**Dept Planning and Environment (now DPHI) analysis –Independent Rapid Assessment of the Parramatta CBD Planning Proposal for DPE (prepared by Bennett and Trimble) March 2022**

## Dept Planning and Environment (now DPHI) analysis –Parramatta CBD Transition Area Review (Hassell) December 2022

## Council Officer analysis of implications of SEPP 2 – June 2023

**Draft Height controls under the then Parramatta CBD Planning Proposal (as at March 2022)**

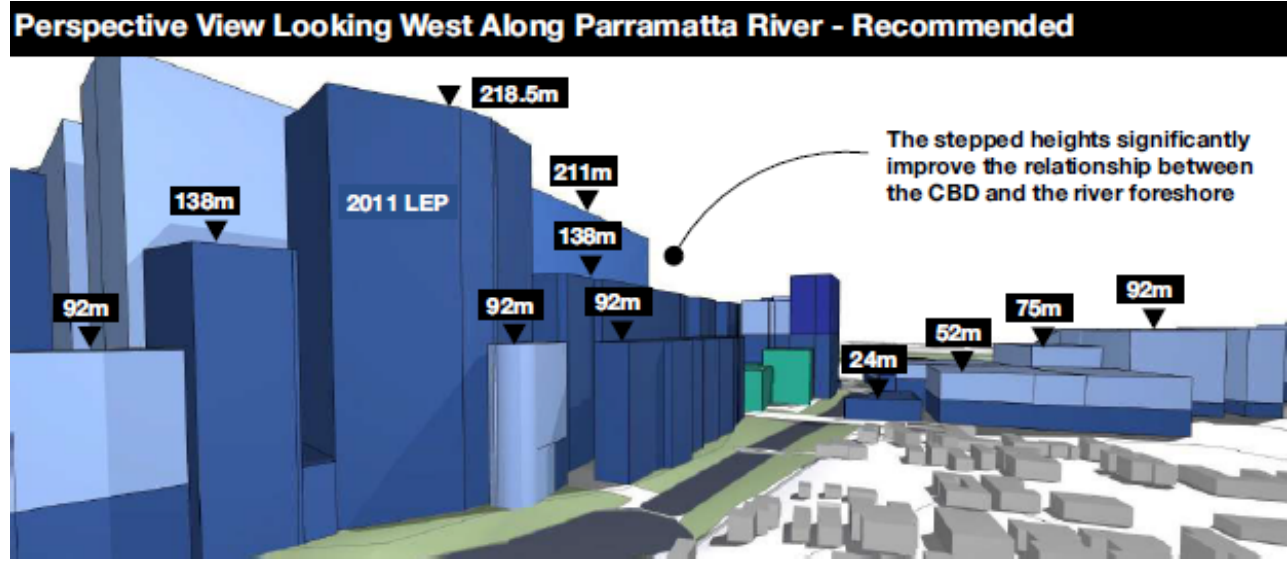
The proposed controls for height incentives, opportunity sites, and the solar access controls for Parramatta Square have loaded height on the southern edge of the Parramatta River foreshore. The resulting massing controls could result in urban form that overwhelms the river that is so central to its landscape and history. It would impact Parramatta’s identity, and its desirability as a place to live and work. The relationships between the recently completed tall buildings and the river is unconvincing. They appear to commercialise the foreshore and visually dominate the river corridor. This type of development is similar to Southbank in Melbourne or Barangaroo in Sydney and may not offer the most sensitive or place-specific response that Parramatta deserves. The relationship between the Sydney CBD and its harbour, and Parramatta and its river, are substantially different in scale, aspect and siting, and yet the proposed controls encourage the same building

typologies, heights and relationship to the water's edge. The scale of development these controls permit risks overwhelming the scale of this important natural, historical and cultural asset.

As the metropolitan centre of the Central River City, the relationship between the river and the CBD will be critical to its future cultural identity and its desirability as a place to live and work. Recommendation: Reduce the proposed height incentives for buildings along the Parramatta River foreshore to protect the natural, historic and cultural qualities that are so central to the identity of Parramatta and its place within the Central River City. The permissible building envelopes should be commensurate with the scale of the river rather than a harbour.

FSR 9.7\*

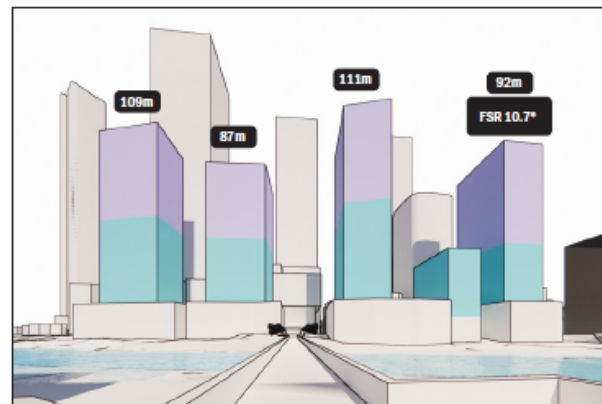
The total recommended maximum FSR is 9:7:1 including all bonuses but is only considered acceptable subject to conditions. This translates to bonus FSR on subject site of 2.5:1. Conditions for subject site include a maximum tower length when viewed from river of 35 metres.

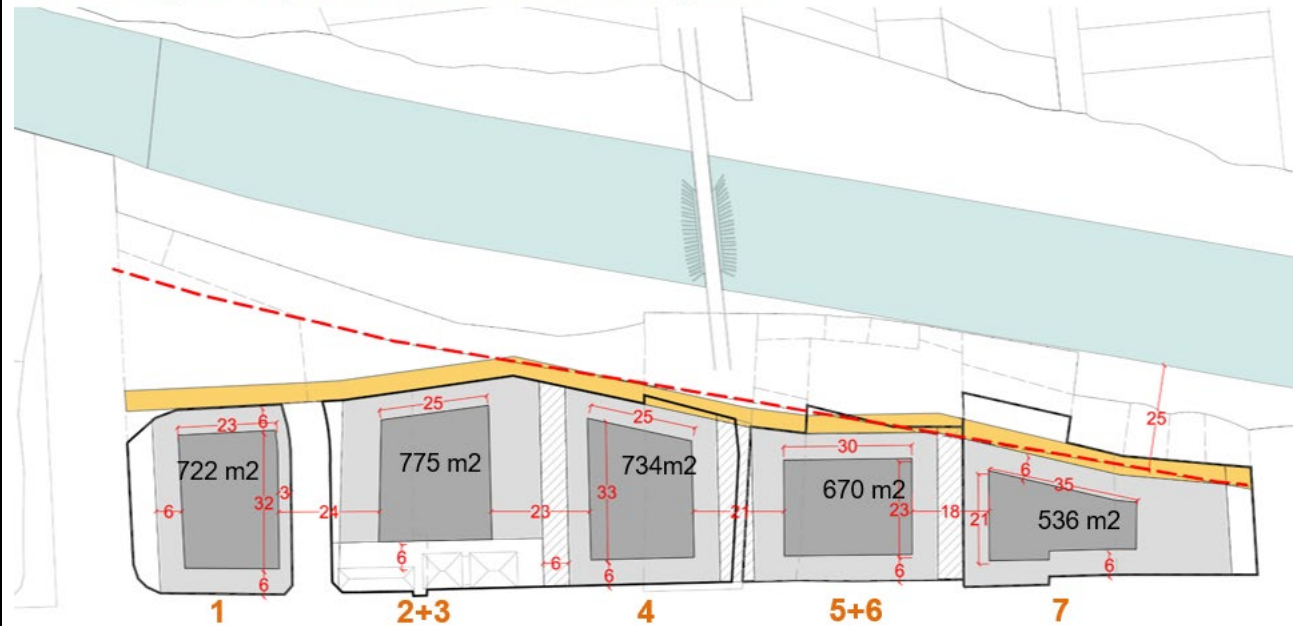
Challenges from current controls:

- No incentive for the site to deliver the upper level promenade.
- Site can achieve HOB of 105m, however cannot achieve FSR of 9.7:1. Can only achieve FSR of 7:1 (Mixed Use) under 105m height control due to limitations of tower width.

<p><b>Outcome</b></p>	<p>The analysis identified issues with the current PLEP 2023 controls for the subject site. The Planning Proposal, in seeking to amend the HOB and FSR controls, may also wish to seek to amend Clause 7.28A of the PLEP 2023 relating to the maximum building width for No. 90-94 Phillip Street.</p>
